December 30, 2003

Refer to: HSA-10/WZ-141  
**Revised**

This is in response to your requests for Federal Highway Administration (FHWA) acceptance of your company's portable sign stands as crashworthy traffic control devices for use in work zones on the National Highway System (NHS). The dates and subjects of the requests are as follows:

### **TF60 STAND**

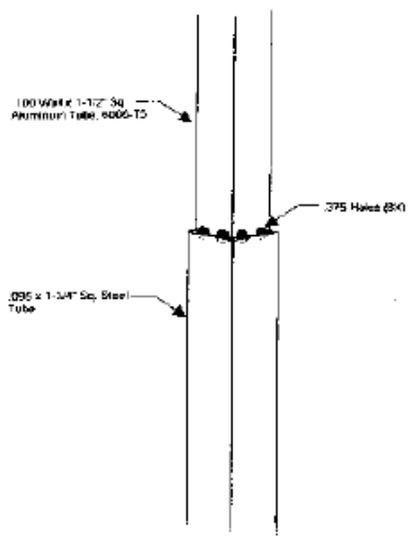
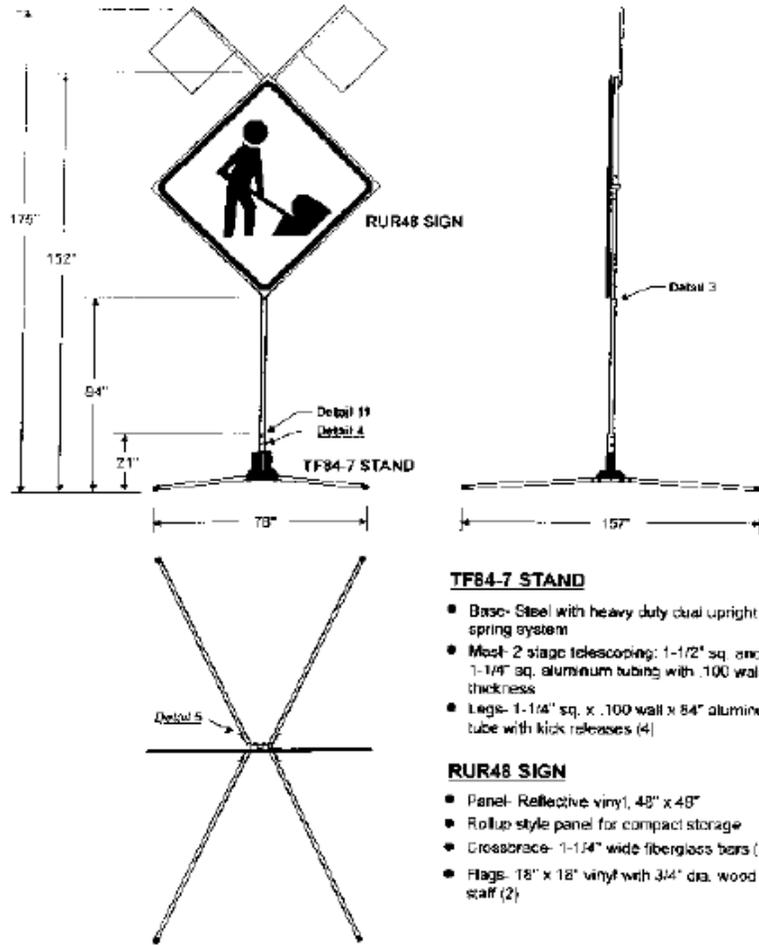
The TF60 Stand shares the same base you tested with rollup signs (stands designated as DF4503 and covered in FHWA acceptance letter WZ-99). You have successfully tested this breakaway concept at the Midwest Roadside Safety Facility (MwRSF) using a rollup sign at a height of 60 inches. Your request is to use this hardware to support rigid, semi rigid, and flexible signs at a height of 60 inches.

During the test DF4503 sign and mast rotated over the vehicle with no potential to contact the windshield. In addition, bogie testing with plywood and aluminum signs (DB 83-87) showed that the breakaway base activated upon impact and the sign did not contact the “vehicle” at the windshield, although contact with the roof would occur. Because the rigid and semi-rigid signs on the TF-60 will be of a greater mass and will raise the center of gravity of the signs, rigid and semi rigid substrates may be used, with or without flags/lights. Signs of these substrates are also likely to stay above the vehicle as they begin to rotate immediate after the impact that activates the breakaway feature. The drilled holes breakaway feature of the TF-60 sign stand is critical, especially for use with the rigid and semi rigid substrates.

- 1) TF60 Stand, breakaway, with rigid, semi rigid, and flexible signs  
Non-reflective vinyl, Superbrite, RS34, Marathon, RS24  
Intepro Plastic 10mm and 12mm, Endurance 10mm and 16mm  
Alpolic 2mm and 3mm, ABS 3mm, 4.7mm, and 6.2mm  
Aluminum 2mm, 2.2mm, 2.5mm, 3mm  
Plywood 9.4mm, 12.5mm, 15.6mm, 18.8mm

**TF84-7 STAND**

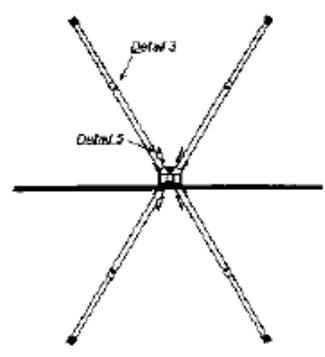
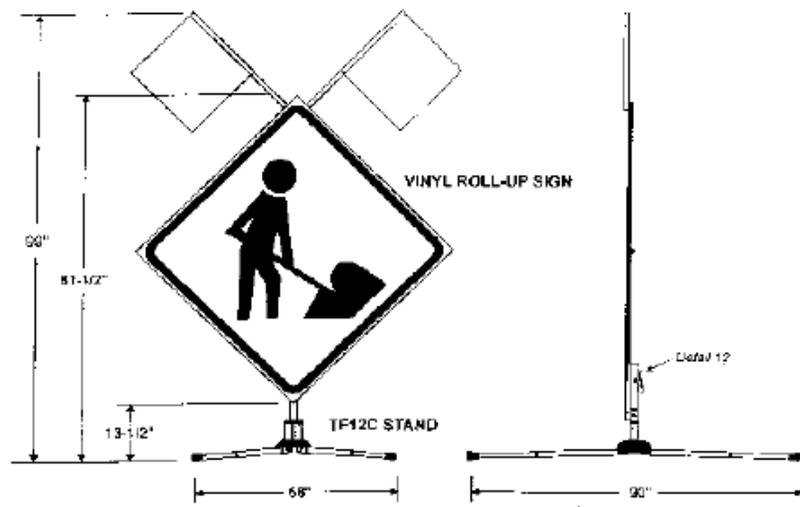
The TF84 stands are designed for use with rollup signs, and are similar to the TF60 Breakaway stand. Each stand consists of a two stage telescoping mast, 1.5 inch square aluminum and 1.25 inch square aluminum with 0.100 inch walls. The mast is supported by a heavy duty dual upright spring system. The TF84 has 84 inch long, 1.25 inch square aluminum legs, while the legs on the TF84-7 stand are 72 inches long. As the breakaway function of this stand will be identical to that of the TF60 stand, and the top of the stand will be 14 inches higher, it will be acceptable for use with rollup signs as requested. Your letter of December 9, 2003, requested the acceptance be for rollup

and rigid signs, including 0.080 and 0.125 aluminum, 10 mm Endurance, and Alpolic substrates. As the TF84 is a taller stand and the additional weight of the solid substrates will raise the center of gravity of the system, it can be expected that the breakaway performance will be enhanced due to the greater height over the vehicle achieved by the stand and sign components. Therefore, the requested substrates will also be acceptable for use as noted.

- 2) TF84, TF84-7 stands with 48 x 48 rollup signs, different leg lengths  
Non reflective vinyl, Superbrite, RS34, Marathon, RS24, also 0.080 and 0.125  
aluminum, 10 mm Endurance and Alpolic

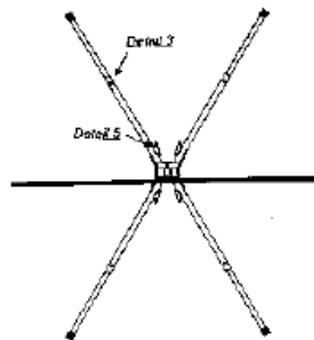
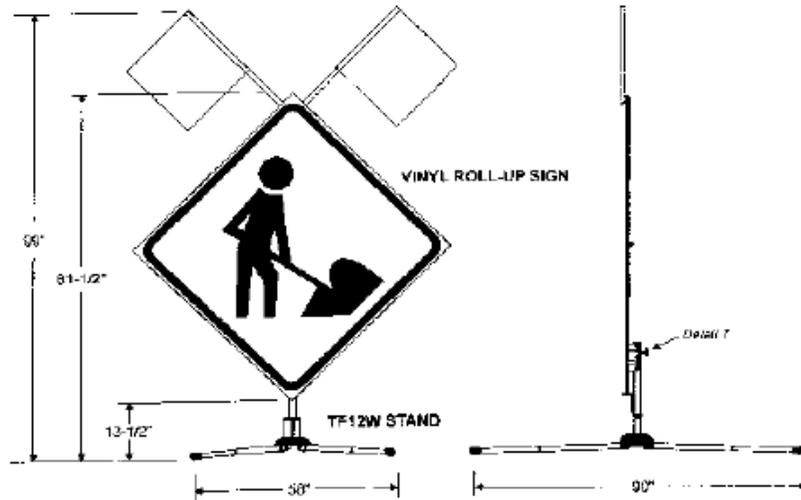
These three “compact” stands consist of single or dual upright springs supporting a short mast. The mast holds the vertical fiberglass rib of a 48 x 48 rollup sign. Your rollup signs use 3/8 inch thick vertical masts and 1/4 inch thick horizontal spreaders. These dimensions are 1/16 inch thicker than those we consider universally acceptable for rollup signs, but your prior crash testing indicates that these signs will perform in an acceptable manner. Bogie testing (DB101, DB102) illustrates the successful performance of the TF12C stand. In these tests, although the sign and/or flags impact at the bottom of the windshield, there are no hard elements involved that could pose a serious threat to the vehicle occupants. The universal sign clamp which is a feature of the TF12W stand, was shown to perform acceptably in FHWA WZ-25.

This compact stand with dual upright springs was bogie tested with a roll up sign. The same roll-up sign was crash tested earlier using a different Dicke Tool stand with successful results. You requested that this sign be acceptable for use with other stands similar to the TF12C.

Test Number	DB-101	DB-102
Sign Stand Tested	TF12C	TF12C
Weight of Tested Stand	23 pounds	23 pounds
Mounting heights	12 inches	12 inches
Flags? Lights?	none	none
Mass of Test Vehicle	820 kg	
Impact Speed	96.8 k/hr (60.1 mph)	96.1 km/h (59.7 mph)
Velocity Change	0.30 m/s	0.83 m/s
Extent of contact	Minimal	Minimal

The bogie tests also show acceptable performance.

- 3) & 4) TF12C, TF12W, UF2000C Compact Stands with roll up signs  
Non reflective vinyl, Superbrite, RS34, Marathon, RS24
- 5) TF12C with RUR44FFS2 Roll Up sign panel  
Non reflective vinyl, Superbrite, RS34, Marathon, RS24

**UF2000C STAND**

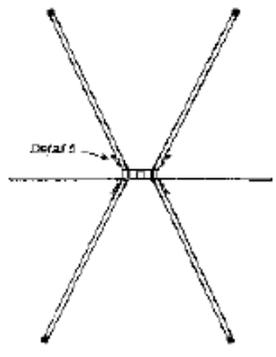
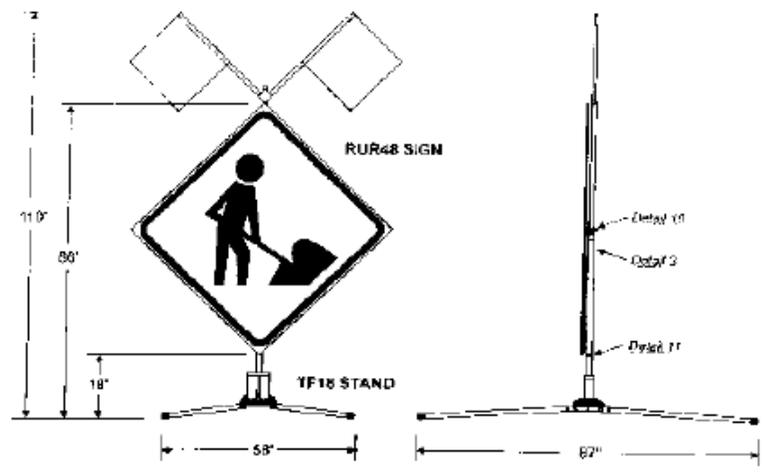
The UF2000S stand features a single upright vertical spring with a “stablock” sign attachment as used in a variety of stands with a variety of spring configurations. The FHWA WZ-17 accepted the stablock feature on a dual upright spring stand, model number DF 3000S. The UF2000C stand consists of a single upright vertical spring with an aluminum channel mounted vertically to display a rollup sign at a 12 inch mounting

height. DB101 and DB102 illustrate the favorable results with the aluminum channel sign attachment, while D18-2 and D23-2 illustrate the favorable results with the UF2000 at 0 and 90 degrees with a clamping mechanism shared by other stands.

- 6) UF 2000S and 2000C with Roll Up sign panel  
Non reflective vinyl, Superbrite, RS34, Marathon, RS24
- 7) & 8) TF18 and STF 18 (see WZ-250) Breakaway Stands with rigid, semi rigid, and  
flexible signs substrates up to 48 inches by 48 inches in size. The acceptable  
substrates include: 5/8 inch plywood with 3-inch radius corners, 0.125  
aluminum or thinner thickness., 2 mm and 3 mm aluminum laminates, 16 mm  
and thinner corrugated plastic, center-hinged 6.35 mm solid ABS plastic, and  
roll-up signs with fiberglass bracing.
